INDIANA DEPARTMENT OF TRANSPORTATION

Design Memorandum No. 19-10

SUBJECT: Terminal Joints

REVISES: *Indiana Design Manual (IDM) Sections 17-5.09(01), 402-7.02(03) and 409-2.04*

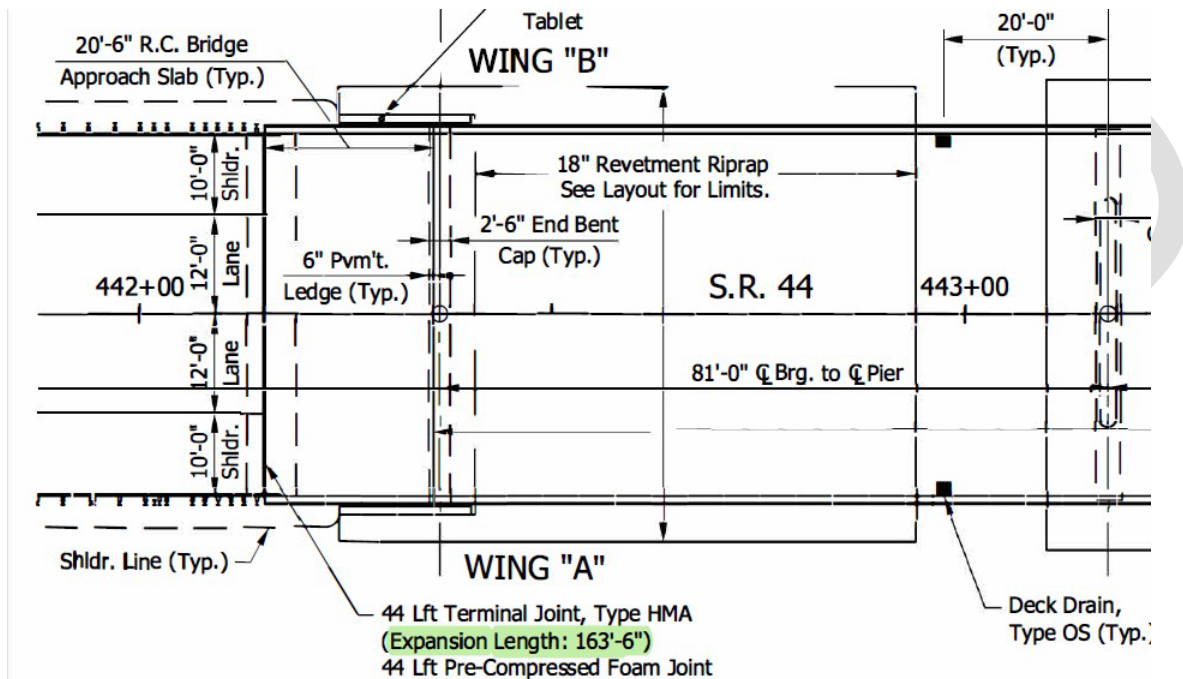
A terminal joint is required where there is PCCP pavement on the approach.

A terminal joint is required where there is HMA pavement on the approach when the following exist

- The bridge has an integral or semi-integral end bent, and
- The bridge expansion > 1/4 in. but not greater than 4 in. 1/4 in. expansion approximately equates to an expansion length equal to 100 ft for concrete and 50 ft for steel.
 - Expansion < 1/4 in. does not require a terminal joint
 - Expansion > 4 in. cannot be accommodated by the terminal joint. A special detail is required.
